Russell Planning and Engineering, Inc. 934 Main Ave. Unit C Durango, CO 81301

RE: Comparison of water and sewer utility lines installed in 2015 - 2016 vs. the VTSV Water and Sewer Master Plans.

Attachment 1 – Water and Sewer Master Plans with comments from Don Schieber and Drew Chandler1/18/2014, marked-up to show water and sewer lines installed in 2015 and 2016.

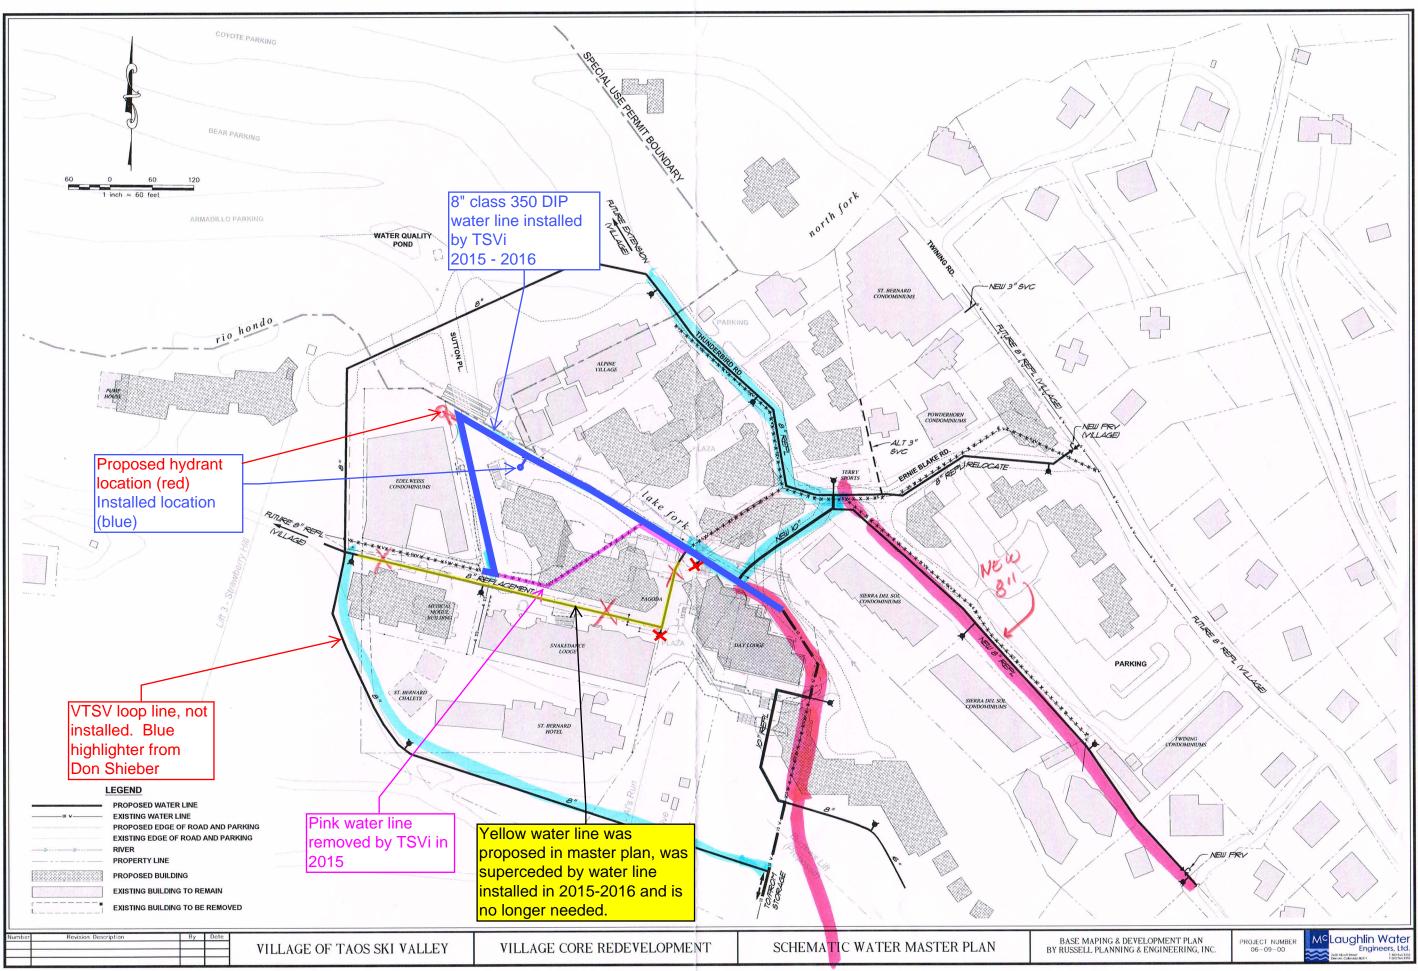
The new water line installed by TSVi (reference dark blue line in the attached Water Master Plan mark-up) is a combination of 8-in and 10-in diameter, ductile iron pipe (d.i.p.), mechanically restrained at every joint. The water line installed is sized and located according to the Water Master Plan, with an alteration agreed to by Drew Chandler and Don Schieber on 1/8/2014. This change involves the routing of the water line further along the north side of the building to Sutton Place rather than beneath the new hotel garage (shown highlighted in yellow). The removal of the 6-in (C-900 and d.i.p.) pipe from under former "Pagoda" building was also called for in the Water Master Plan.

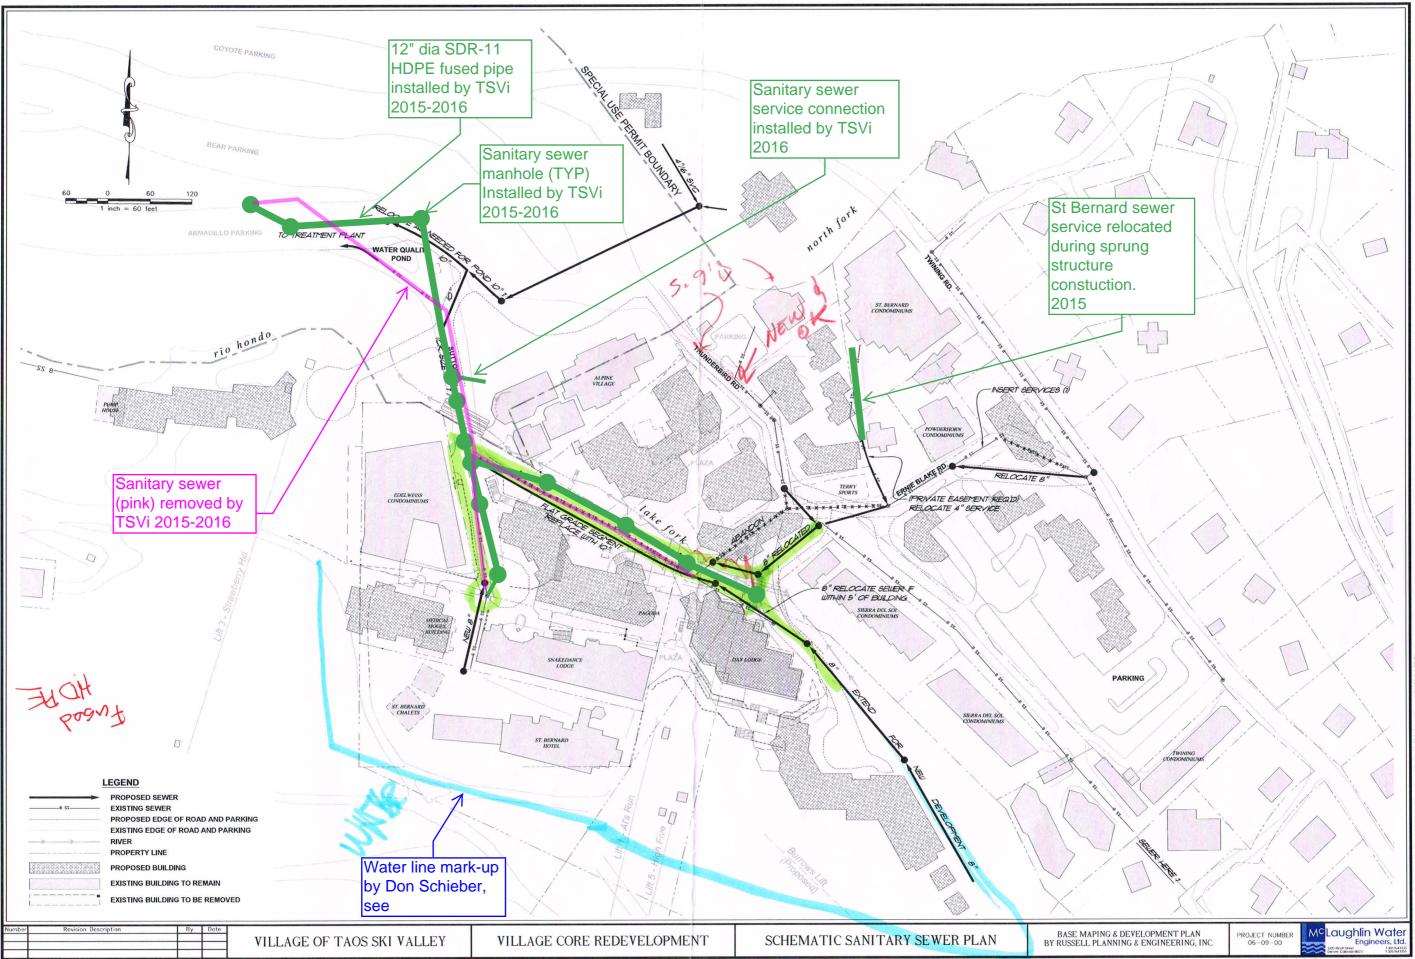
The new sewer line installed by TSVi (reference dark green line in the attached Sewer Master Plan mark-up) is a combination of 8-in and 12-in diameter DR-11 High Density Polyethylene (HDPE) pipe with fusion-welded joints as required by Don Schieber. Due to the wall thickness of the DR-11 pipe, a 12" size was selected to ensure that the resulting 10" inner diameter was maintained to meet the size requirements of the Sewer Master Plan. The new sewer line installed between the hotel and the river replaces an existing 10 inch PVC pipe that had historically been prone to obstruction due to a sag in the vertical

alignment. The three manholes installed in the corridor have locking manhole covers, waterproofing ad-mixture added to the concrete barrel sections, barrel gaskets and barrel joint water-proofing wrap.
